Title: Permit 22-016: Morningside Flood Risk Reduction Project

Project/File: 227701403 22-016

Reference: Edina Morningside Flood Risk Reduction Project Technical Summary

MORNINGSIDE STORM SEWER AND DRAINAGE

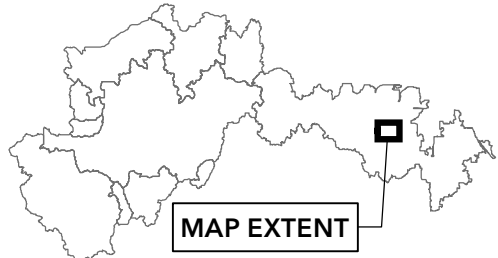
The project is proposed in the Morningside neighborhood of Edina, which discharges via storm sewer to St Louis Park, before entering the City of Minneapolis and subsequently, stormwater ponds that serve as pretreatment for Bde Maka Ska, and Bde Maka Ska itself. See the “Morningside Storm Sewer and Drainage” figure that accompanies these memos.
